Access Compliance Report Public Rights-of-Way (Curb Ramps)

Main Street: ST_ALBANS_DR		Cross Street: MONTECITO_RD		Location:	SE
ADA ID: RPRK211220113034	Ramp Type:Type 1 - Perpendicular Diagonal Initial Pass/Fail: Pass		Overall Compliance: No	Severity Score:	4
Codes/Mitigation Info/Possible Solution			Field Measurements/Component Compliance

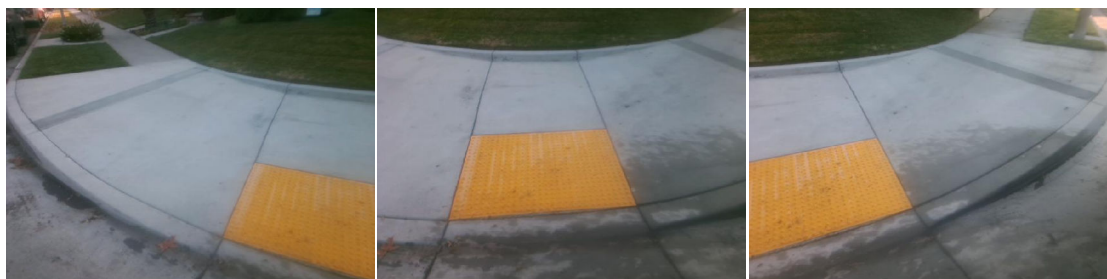
R304.2.2, R304.2.1, STD 1115

Remove & Replace Curb Ramp With Two New Directional Ramps or Equivalent.
